## Product Change Notification / SYST-08OAYW733

ERRATA - PIC24FJ256GB110 Family Silicon/Data Sheet Errata Document Revision

## PIC24FJ256GB110 Family Silicon Errata and Data Sheet Clarification

The PIC24FJ256GB110 family devices that you have received conform functionally to the current Device Data Sheet (DS39897C), except for the anomalies described in this document.

**FIGURE 2-3 FREQUENCY vs. ESR PERFORMANCE FOR SUGGESTED VCAP**

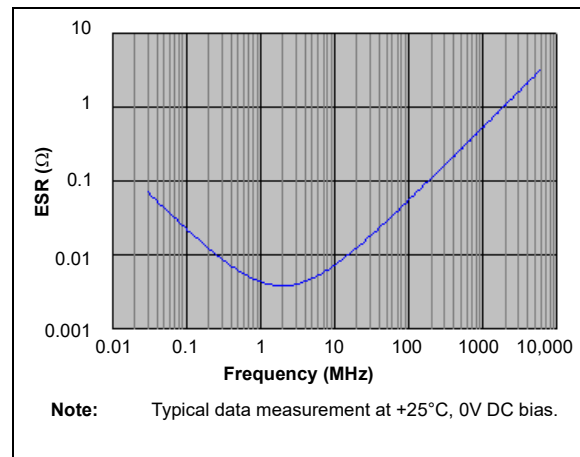
Designers may use [Figure 2-3](#) to evaluate ESR equivalence of candidate devices.

When the regulator is disabled, the VCAP/VDDCORE pin must be tied to a voltage supply at the VDDCORE level. Refer to **Section 29.0 “Electrical Characteristics”** for information on VDD and VDDCORE.

**FIGURE 2-4 DC BIAS VOLTAGE vs. CAPACITANCE CHARACTERISTICS**

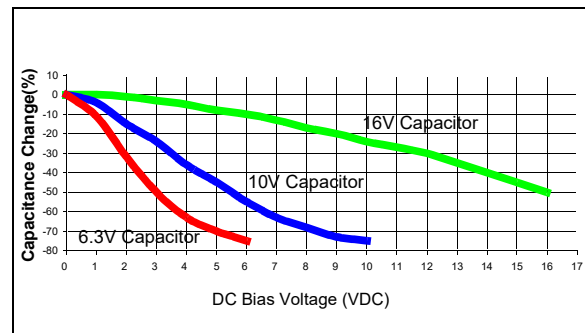
A typical DC bias voltage vs. capacitance graph for 16V, 10V and 6.3V rated capacitors is shown in Figure 2-4.

When selecting a ceramic capacitor to be used with the internal voltage regulator, it is suggested to select a high-voltage rating, so that the operating voltage is a small percentage of the maximum rated capacitor voltage. For example, choose a ceramic capacitor rated at 16V for the 2.5V core voltage. Suggested capacitors are shown in Table 2-1.

**FIGURE 29-1: PIC24FJ256GB110 FAMILY VOLTAGE-FREQUENCY GRAPH (INDUSTRIAL)**

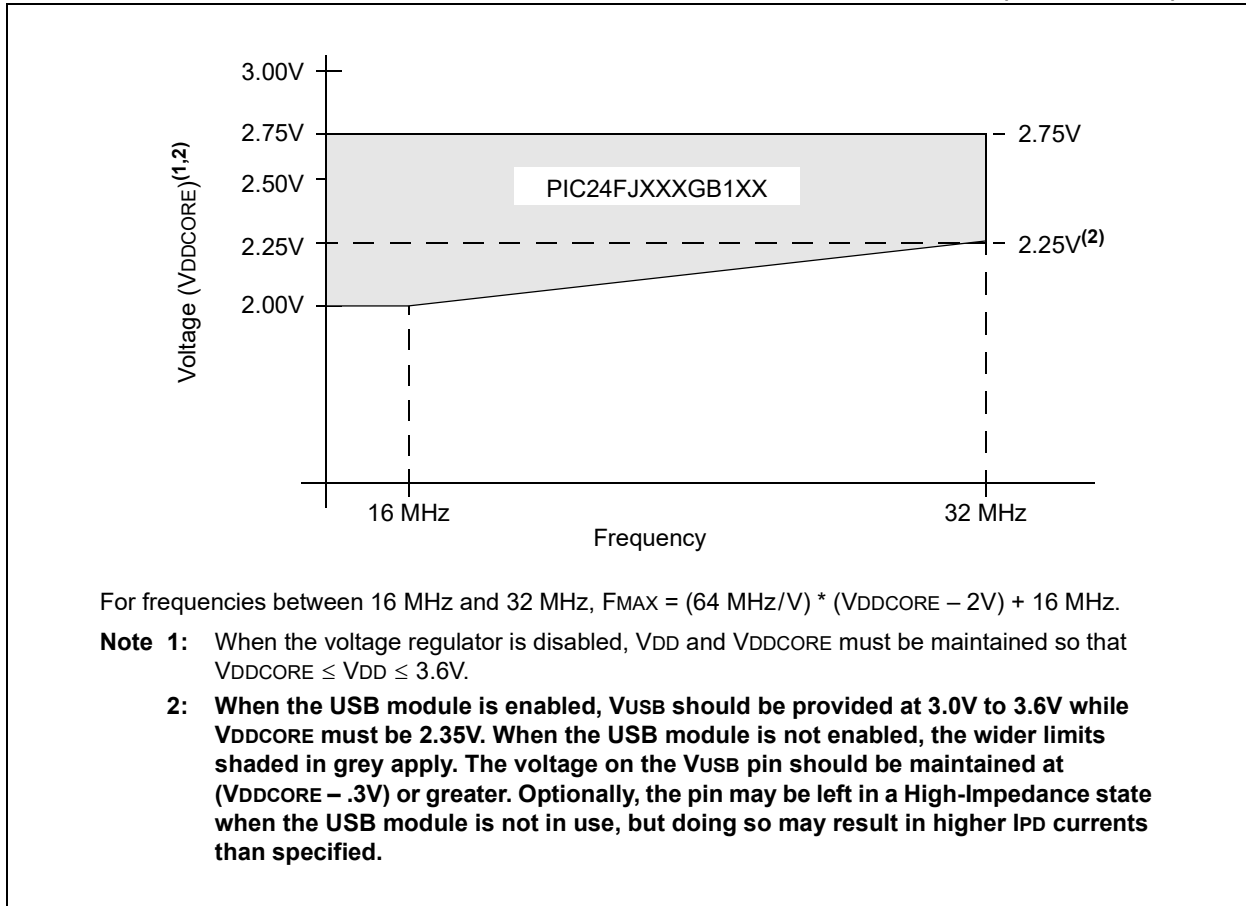
Figure 29-1 (“PIC24FJ256GB110 Family Voltage-Frequency Graph”) is amended by adding an additional footnote. The updated figure is shown below (changes in **bold**; bold in original removed for clarity).
